ELECTRICAL SAFETY FOLLOW UP INSPECTION REPORT (4TH)

| Factory Name | Safaa Sweaters Ltd. | | | Note: | Modification work is going on LPS due to installation of new railing on parapet wall. |
| FACTORY ID | 12362 | ELECTRICAL SAFETY INSPECTION DATES | | | Other Factory: |

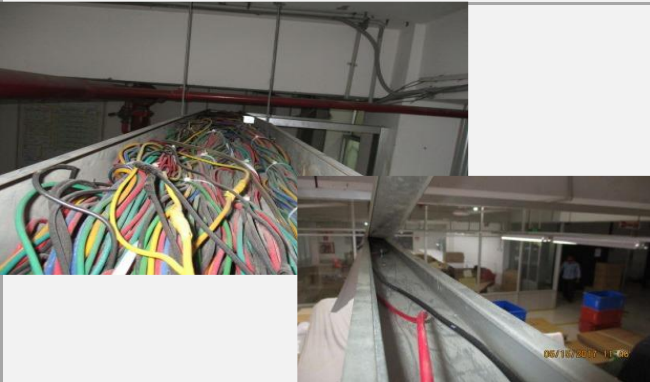
| Item No | Accord Inspection Observation | Accord Action Plan (Recommendation) | Accord Time line (given in report) | Comments from Accord (After Physical Inspection) | Final Timeline (Approved timeline) | Final Action Plan (Factory) | Progress Status (On the date of inspection) | Pictorial Evidence |
|---------|---|--|------------------------------------|--|------------------------------------|---|---|---|
| 17 | Cables laid across passage on floor through flexible PVC conduit. | Use steel pipe (instead of flexible pipes), clamped with saddle on floor, to ensure the mechanical protection of cable/wire insulation. Remove and reinstall the mechanical device to its respective supporting frame of boiler. | 2 Weeks | On 24/05/2016: Corrected. | 24/05/2016 | Corrected ; on 1st ACCORD follow up 24/5/16 | Corrected | |
